**City of Ketchum
Planning & Building**

**STAFF REPORT
KETCHUM PLANNING AND ZONING COMMISSION
MAY 7, 2026 MEETING**

PROJECT: 233 Parkway Variance

FILE NUMBER: P25-059

Figure 1 Proposed Two Vehicle Garage

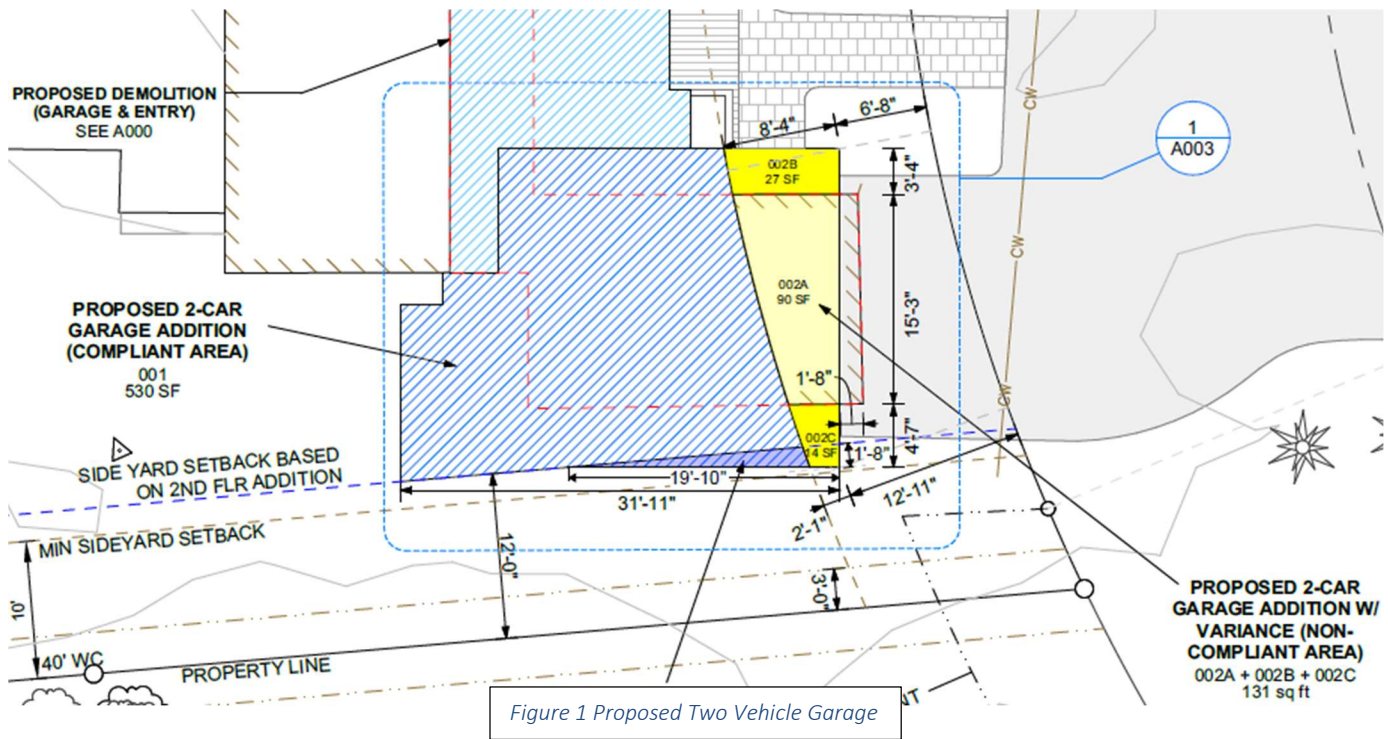
- Reduced encroachment of proposed garage into the front setback to 8'-4"
 - o 1'-10" less than the 10'-2" front encroachment of the previous design
- Proposed garage is setback 1'-8" from the plane of the existing garage
- Reduced the proposed maximum building height to 24' from 26'
- Clarified the encroachment of the proposed garage into the south side setback is 1'-8", reduced from 3' in the previous design
- Total nonconforming building area reduced from 175 square feet to 144 square feet from the previous design
 - o Net increase of 30 square feet nonconforming building area
- Revised design to remove side yard encroachment of the south roof deck overhang.

In response to the Commission’s feedback regarding minimizing the request, the applicant has made certain targeted revisions to the design. The revised design reduces the encroachment into the front setback to 8’-4”, which is 1’-10” less than the 10’-2” front encroachment in the previous design. Also, by reducing the width of the interior stair, the plane of the proposed garage was able to be set back 1’-8” from the plane of the garage’s existing encroachment. The revised design also reduced the encroachment into the south side setback from 3’ to 1’-8”. The building height of the design has been reduced from 26’ to 24’, which establishes a 12’ minimum required side yard setback. All new floor area beyond the minimum needed for a two-vehicle garage, such as the storage area to the rear of the garage and second level deck, are aligned with the 12’ side setback requirement.

Figure 2 Existing non-conforming portion in question

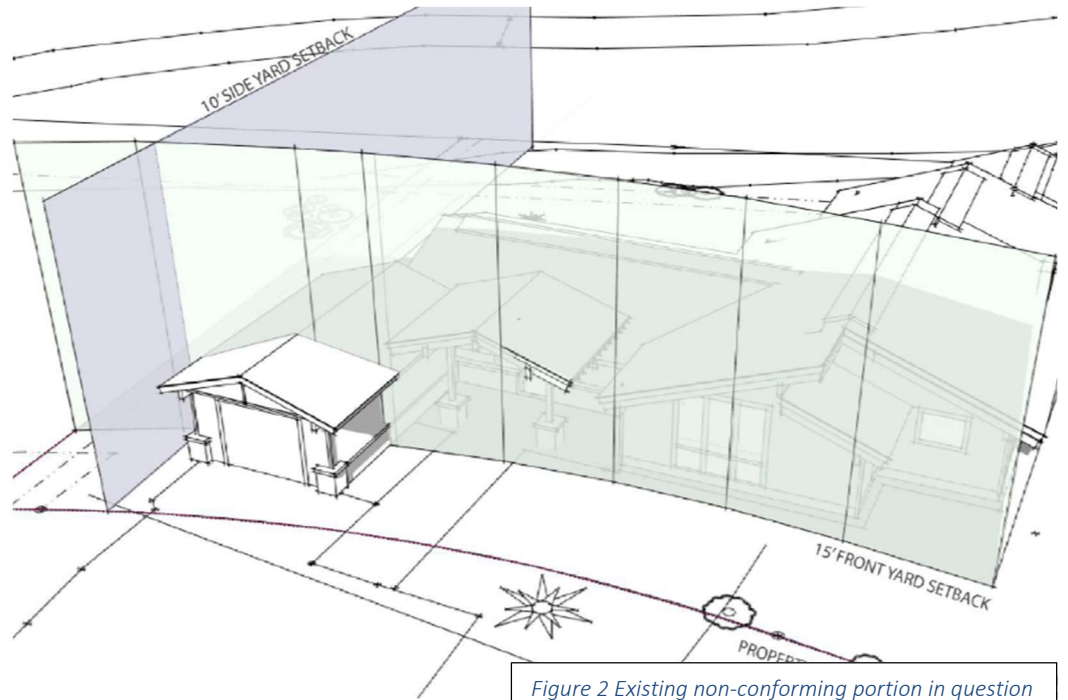
The existing single-car garage is nonconforming as it encroaches within the minimum required front setback. The existing encroachment is a 15' span of the building that extends into the front setback by 8'-10" at the north end and 5'-6" at the south end. As shown in Figure 1 below, the revised design proposes an encroachment into the front setback that is a 23'-1" span of the building that extends into the front setback by 8'-4" at the north end and 2'-1" at the south end and a maximum of 1'-8" into the

The variance request does not create a new nonconforming condition, as the existing garage is already nonconforming and will remain so regardless of approval of the variance request. The proposal modestly modifies an existing nonconformity while bringing the property into compliance with off-street parking requirements. The proposed

Figure 3 Proposed non-conforming portion

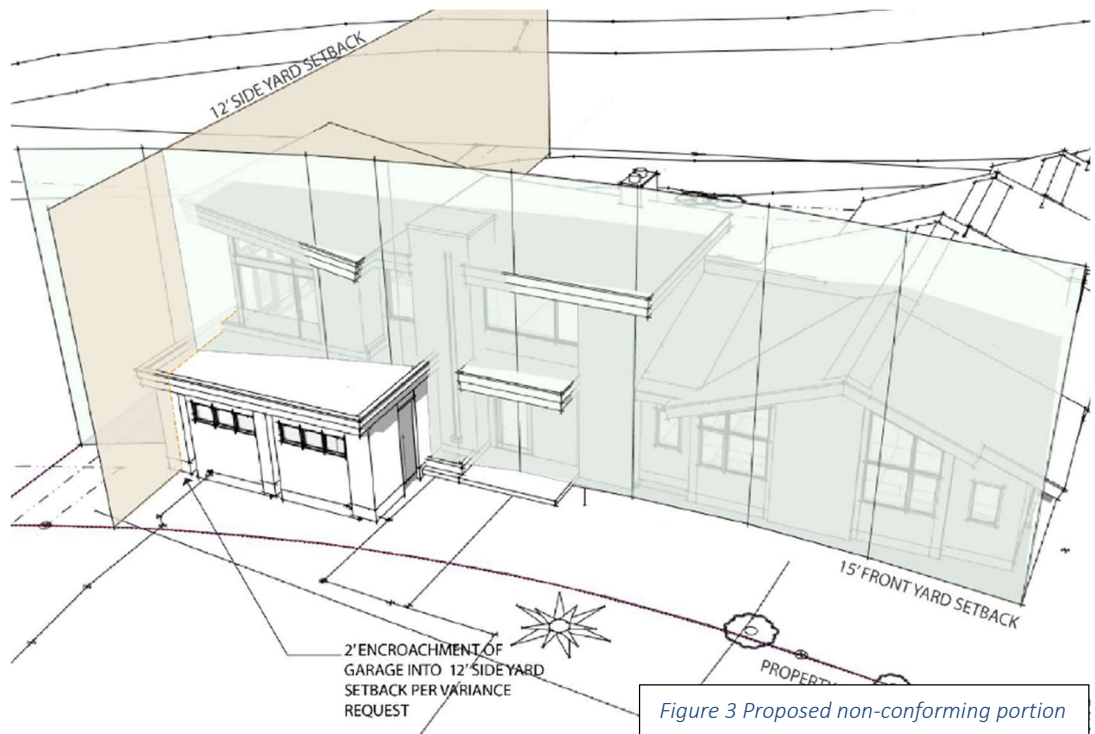
encroachment totals 144 square feet, reduced from the 175 square feet of the previous design and is a net increase of just 30 square feet of nonconforming area from the existing garage. See Figures 2 and 3 for a comparison of the massing of the existing and proposed encroachment.

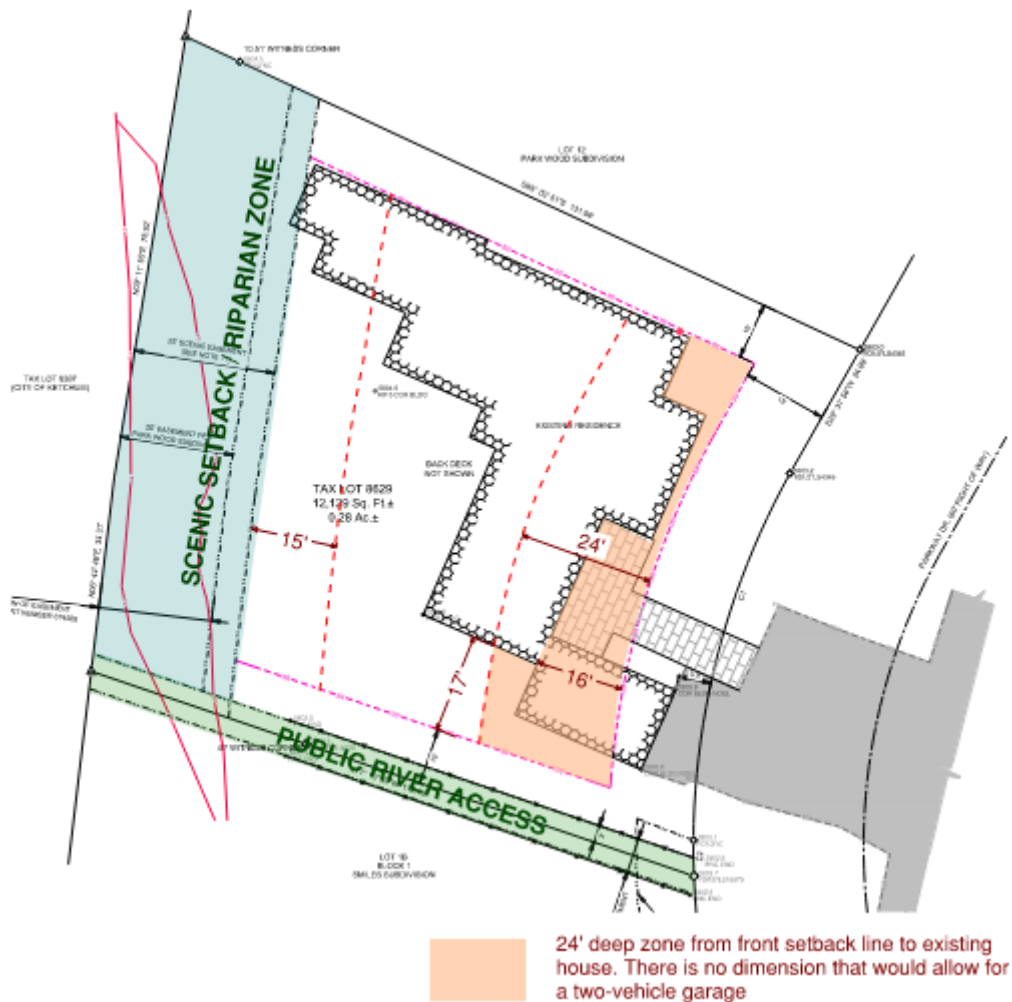
The existing non-conforming single vehicle garage encroaches into the front yard setback 8'-10" at the northeast corner of the garage. The total existing area of the encroachment into the front yard setback totals 114 sf.

The proposed garage addition in the revised design reduces that encroachment to 8'-4" by moving the front, street facing plane of the garage 1'-8" back from the existing plane of the garage. The proposed total front yard encroachment is 131 sf, a net increase of 17 sf.

To keep the front yard setback encroachment to the minimum extent as possible, a variance is also requested for a 1'-8" encroachment into the 12'-0" side yard setback established by the proposed 2nd floor addition building height at a maximum of 24'-0". The proposed side yard encroachment reduces to 0" at 19'-10" back from the southeast corner of the garage. The side yard encroachment totals 13 sf.

The total proposed encroachments into the front and side yard setbacks would be 144 sf, a net increase of 30 sf from the existing non-conforming garage encroachment. The proposed variance request is for an incremental and minimal expansion to grant relief and remove the non-conforming second vehicle parking space.

Figure 1 – City Construction on Water line @ Driveway

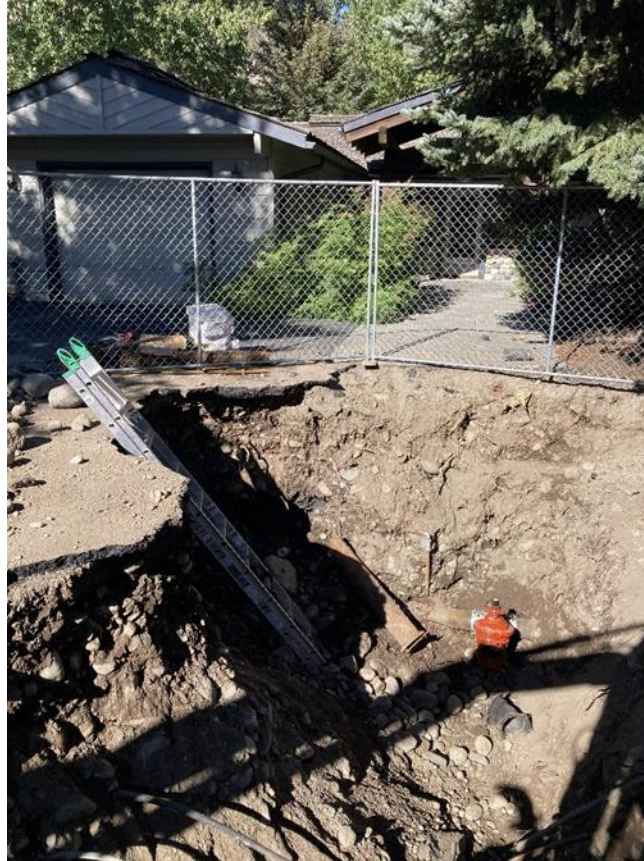
- iii. **Due to the paved section of Parkway Drive being offset significantly to the east of the centerline of the public right of way, the public utilities in the street run through what is perceived as the front yard and driveway for 233 Parkway. When work has been required on these utilities the owners have lost vehicular access to their garage and lost full use of their driveway.**

A001

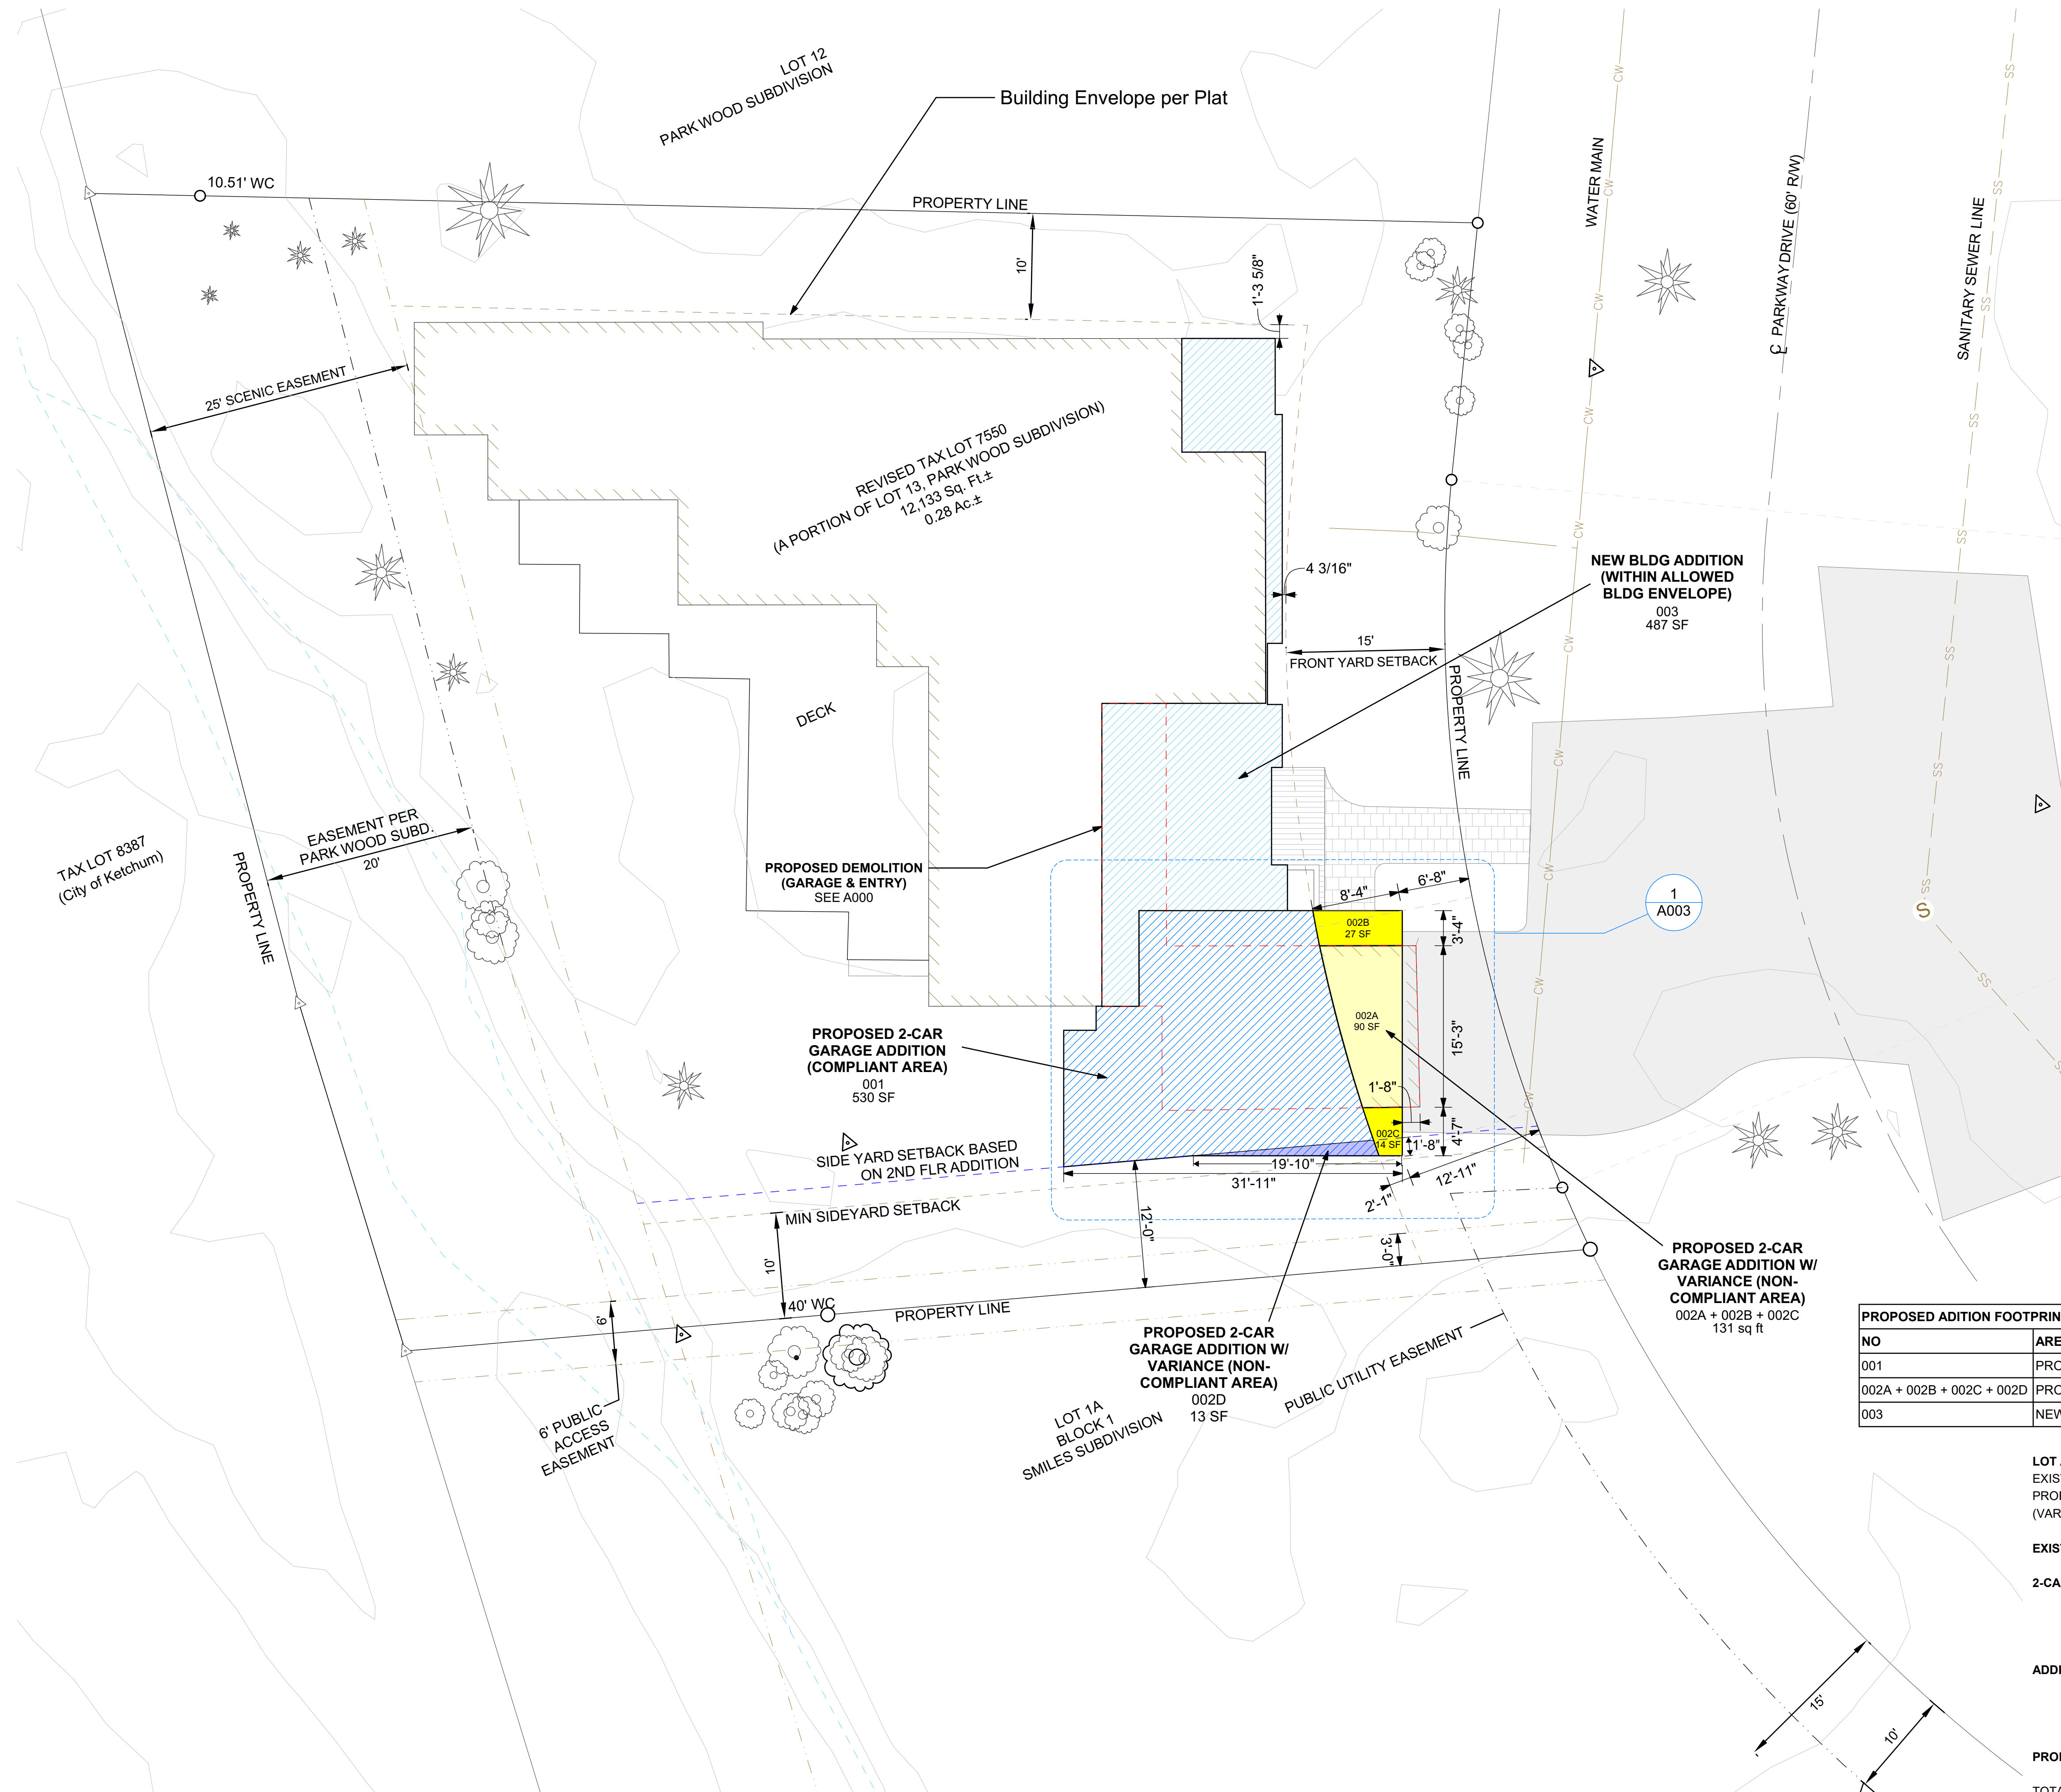
Refer to sheet A001 and A003 for graphic reference of the dimensional information referenced in the narrative.

- iii. In the revised design, the front plane of the proposed garage has been setback 1'-8" from the existing plane of the garage. The previous design aligned with the existing plane. The proposed garage would encroach 8'-4" into the front yard setback.

- i. By reducing the width of the interior stairs, the plane of the proposed garage was able to move back 1'-8" from the existing garage plane.
- ii. Any area beyond the minimum needed for a two-vehicle garage, such as the storage area at the back of the garage or second level deck is now aligned with side yard setback of 12' and subject to all other development standards. These areas outside the two-vehicle parking area of 24' x 24' do not require a variance
